Proposal #19: 4494-07-71, WISC 2024342
Buchanan - Holland
Kankapot Creek Bridge
CTH KK
Outagamie County

This is Addendum No. 01, which provides for the following:

ADDENDUM NO. 01

Addendum No. 01
 ID 4494-07-71
 Revised Sheet 3
 May 6, 2024

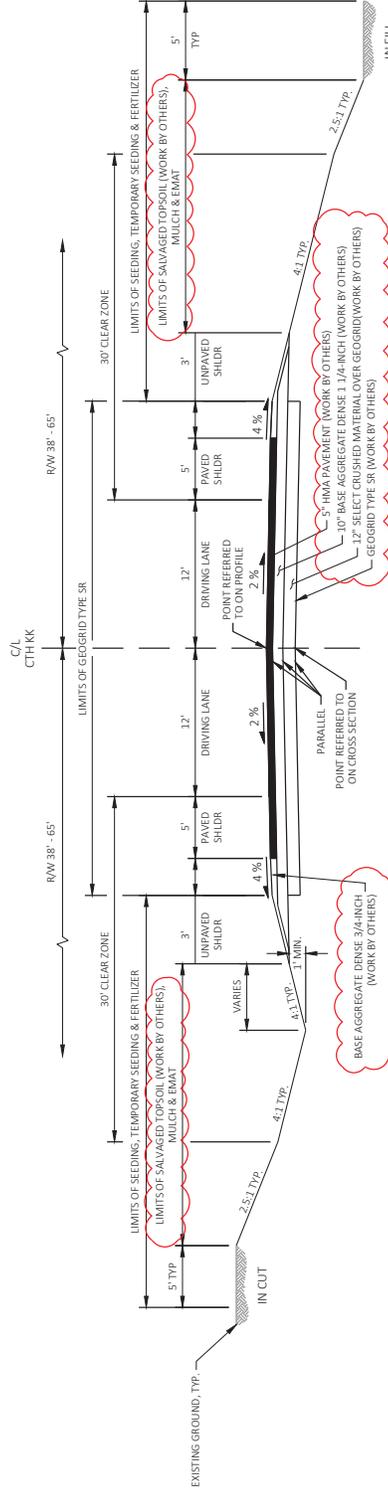
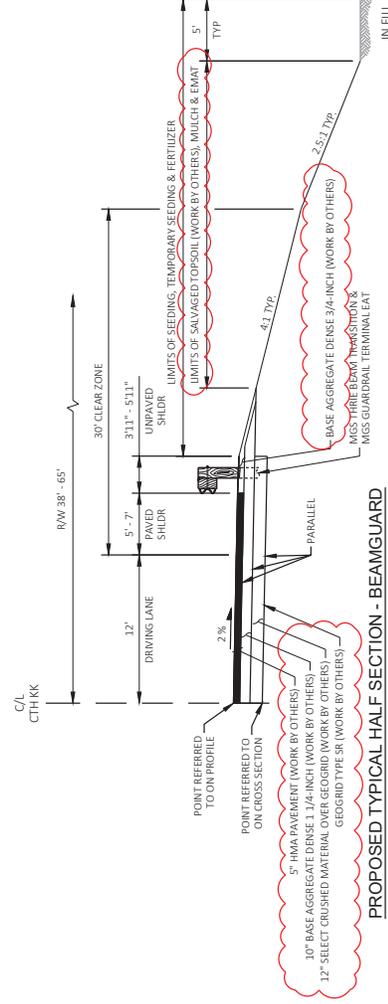
Revised Plan Sheets	
Plan Sheet	Plan Sheet Title (brief description of changes to sheet)
3	Typical Section. Added "Work By Others." notes to Outagamie County work items.
5	Detour Route. Added "For Information Only. Work By Others." note.
6	Detour Route. Added "For Information Only. Work By Others." note.
7	Detour Route. Added "For Information Only. Work By Others." note.

Addendum No. 01
ID 4494-07-71
Revised Sheet 6
May 6, 2024

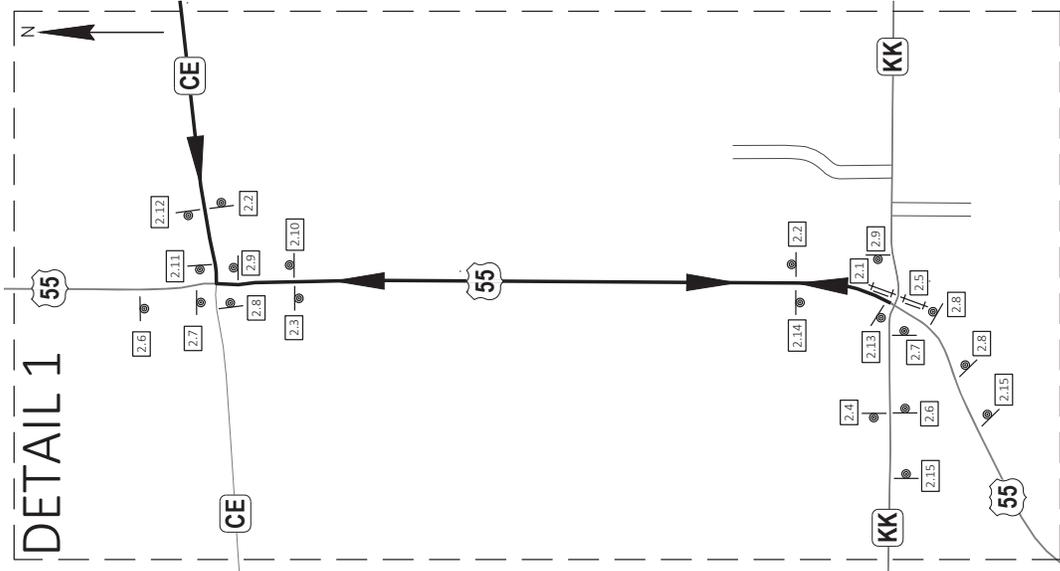
FOR INFORMATION ONLY - WORK BY OTHERS.

Addendum No. 01
ID 4494-07-71
Revised Sheet 7
May 6, 2024

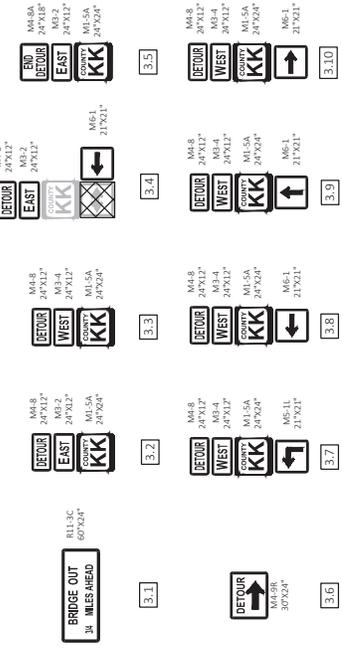
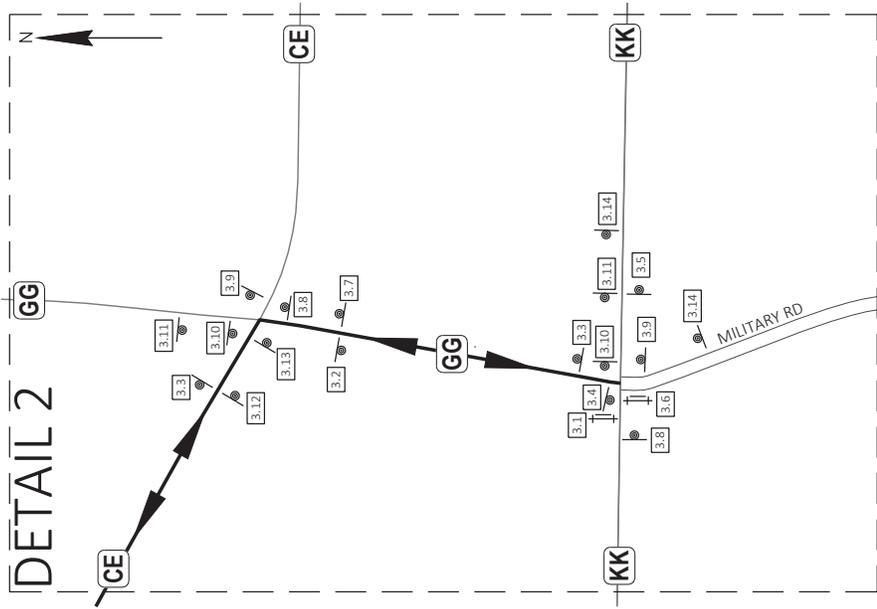
FOR INFORMATION ONLY. WORK BY OTHERS.
